DIABLO CANYON UNIT 1  
INDEPENDENT DESIGN VERIFICATION PROGRAM  
ELECTRICAL EQUIPMENT ANALYSIS  
ITR #33  
REVISION 1

Docket No. 50-275  
License No. DPR-76

INTERIM TECHNICAL REPORT

ELECTRICAL EQUIPMENT BY ANALYSIS

Figure 4  
 Design Analysis Dynamic Model For  
 Hot Shutdown Remote Control Cabinet

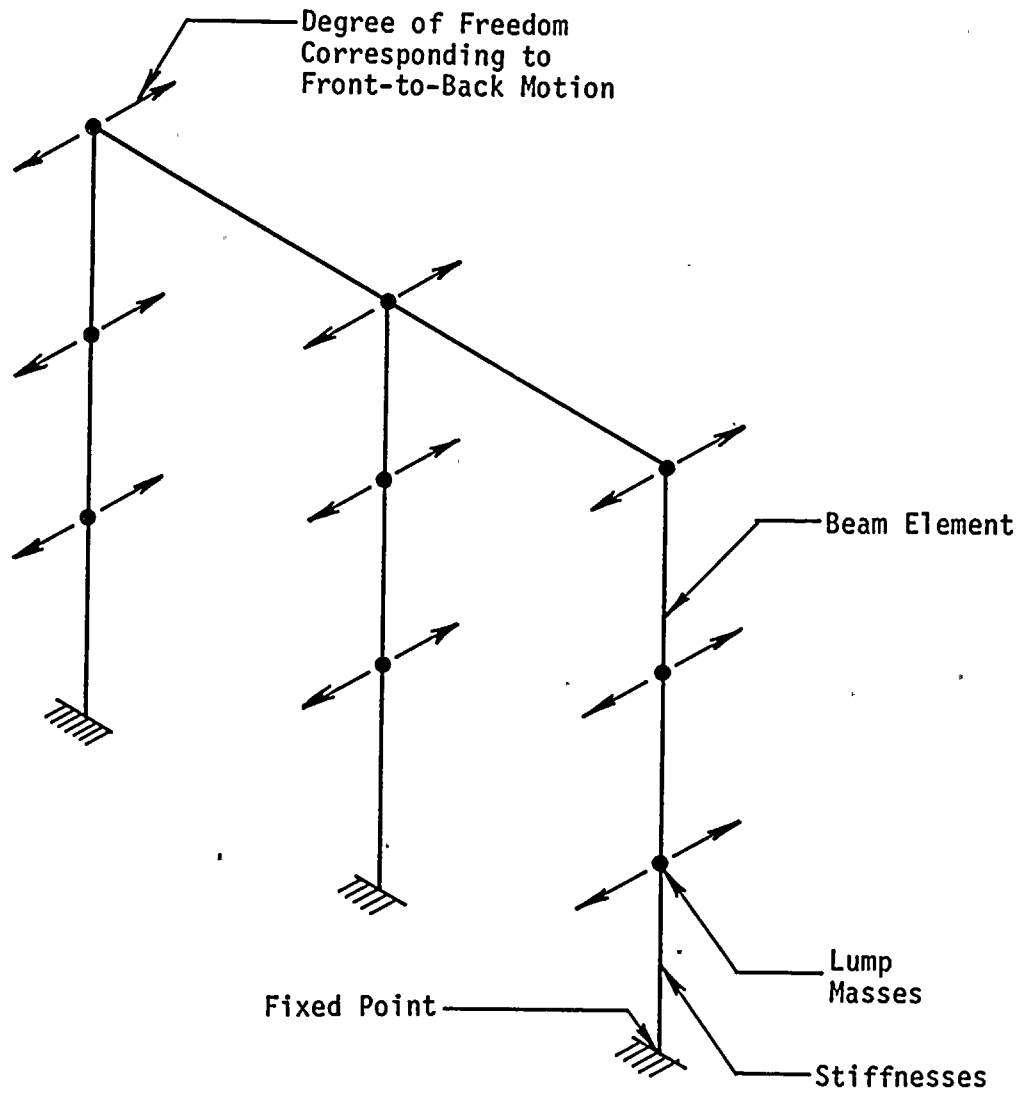
The design analysis examined the front to back vibrational frequencies using a lump mass model with nine dynamic degrees of freedom (as shown in Figure 4). The side-to-side and vertical natural frequencies were determined by inspection to be greater than those for the front-to-back direction, based on the fact that the doors are closed during normal plant operation (Reference 11).

Both the verification and design analyses of the overall cabinet structure considered the cabinet's front-to-back direction to be the most flexible direction. However, the methodologies used to represent the front-to-back characteristics differed: while the verification analysis used a single degree of freedom model based on a reduced cross-section of the cabinet, the design analysis used a lump mass and beam element model with nine lumped masses.

EOI 1087 reports differences of greater than 15% between the independent analysis results and the design analysis results. This EOI was subsequently closed because the IDVP showed all stresses to be below the allowable stresses.

Figure 8

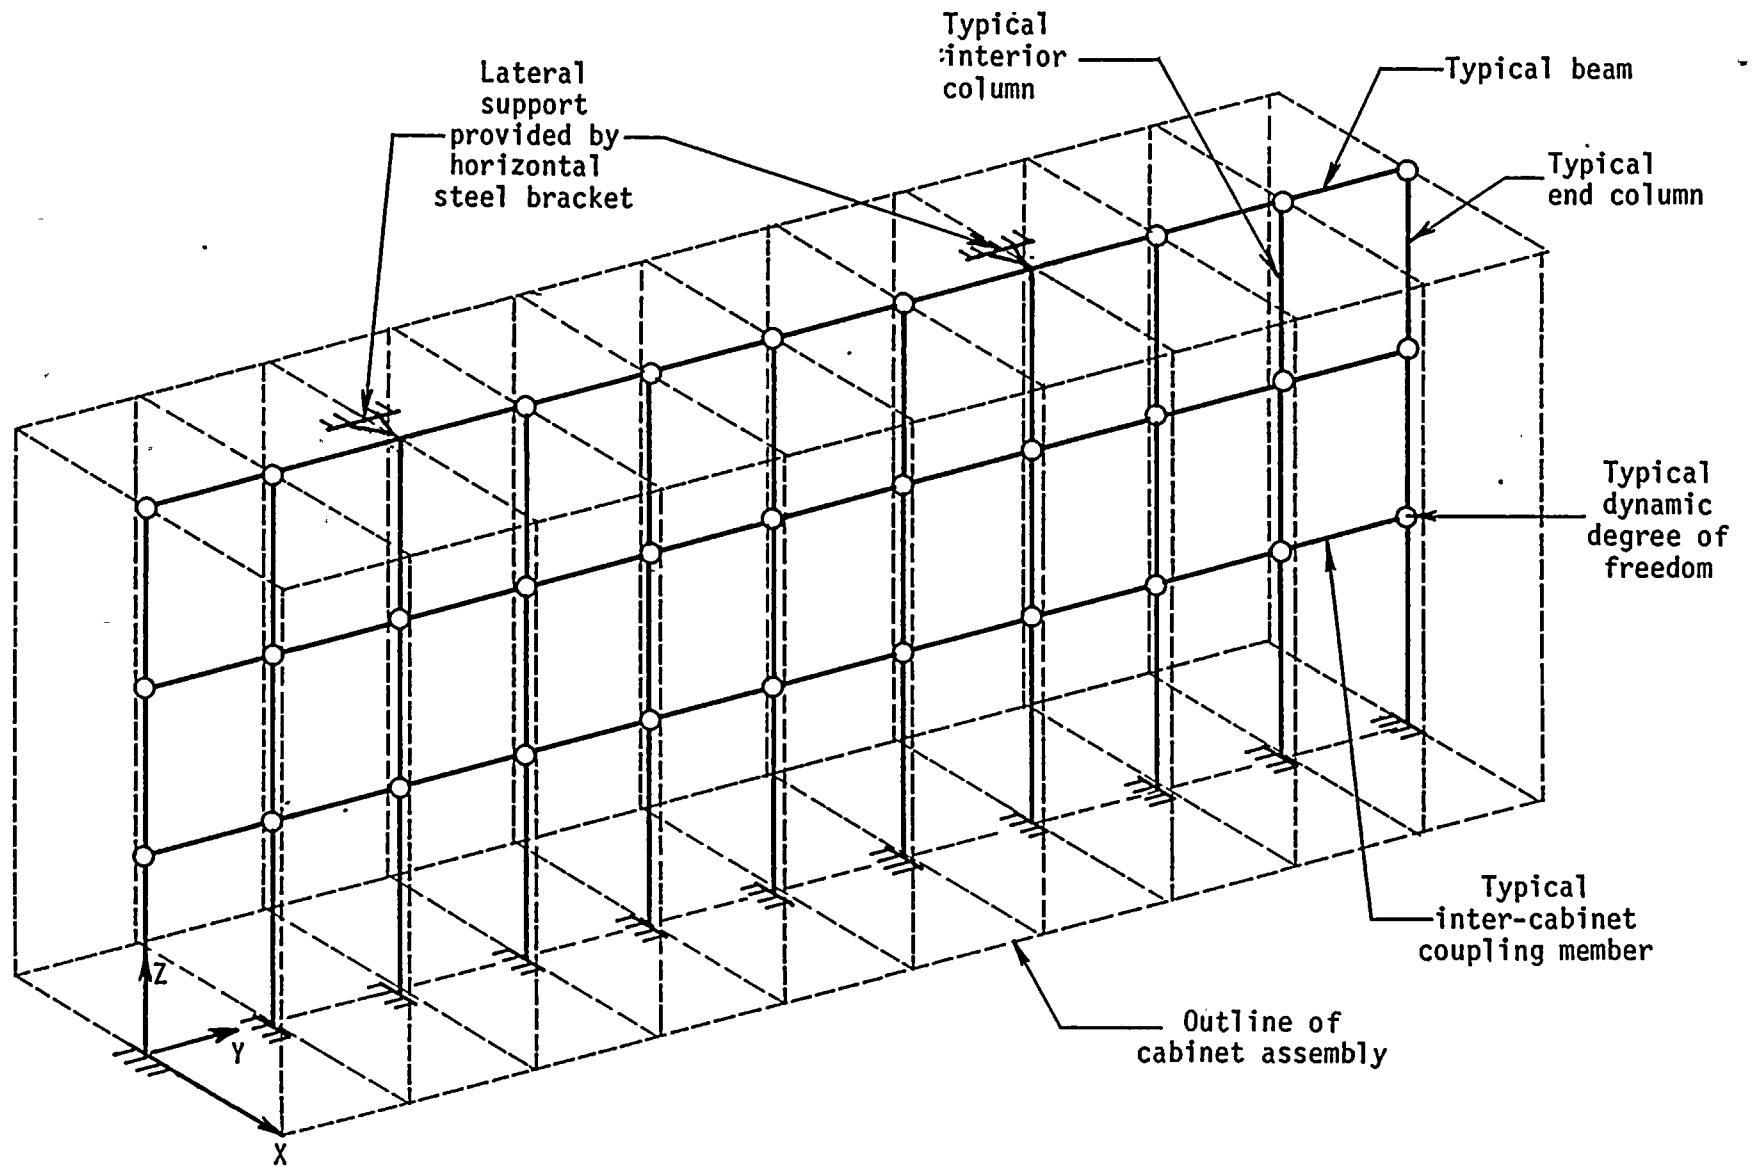
The design analysis of the main annunciator cabinet assembly modeled the dynamic characteristics using a lump mass and beam element computer model (Reference 14). The model, shown in Figure 8, only accounted for the front-to-back (East-West) motion of the cabinet assembly. The design analysis concluded that the cabinet assembly is rigid in the side-to-side direction because the doors were assumed to provide a substantial stiffness contribution in that direction when they were closed.

The difference between the design analysis and the verification analysis is that the design analysis assumed that the cabinet assembly was rigid in the side-to-side (North-South) direction. Thus, the design analysis did not account for the effects of the amplified structural response in the side-to-side (North-South) direction.

EOI 949 was issued because the loads (determined by the IDVP) on the concrete expansion anchors securing the truss bracing to the wall exceeded the allowable. In addition, the design analysis assumed that the cabinet was rigid in the side-to-side direction. The concrete expansion anchor loads exceeded allowables because the design analysis did not examine the side-to-side motion based on this rigidity assumption. The IDVP found the side-to-side natural frequency of the structure to be in the flexible range..

PGandE is modifying the main annunciator cabinet assembly to make the cabinet assembly rigid in the side-to-side direction. EOI 949 is described as an Error Class A or B pending IDVP verification of the modification.
